Office Action Summary

10/772,330

SUTTLE, TERRY LYNN

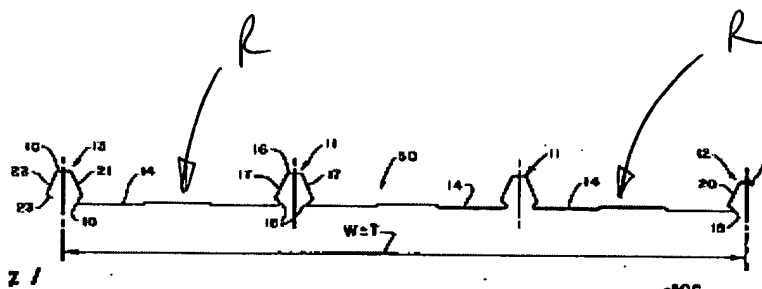
Claims 1-4,9-11 and 14 are rejected under 35 U.S.C. 102(b) as being anticipated by US Patent #4,486,998 to HAGUE. HAGUE discloses a structural panel including a sheet material having a plurality of elongate ribs (11,12,13,etc.) and (R), see below; and

a sealing cap (28) that engages an adjacent pair of elongate ribs (11,12,13,15,etc.). Regarding claim 2, the elongate ribs include a plurality of upright ribs (11,12,13,15,etc.) and a plurality of partial height ribs (R). In reference to claims 3 and , at least two upright ribs (11,12,13,15,etc.) are adjacent one another and are adjacent at least one partial upright rib (R). Regarding claim 9, the sealing cap is U-shaped and engages a pair of upright ribs (11,12,13,15,etc.). In reference to claim 10 and 11, the sheet material is waterproof. Regarding claim 14, the upright rib (11,12,13,15,etc.) and partial

ribs (R) are adapted to overlies and engage adjacent upright and partial ribs disposed at an edge of a substantially identical panel.
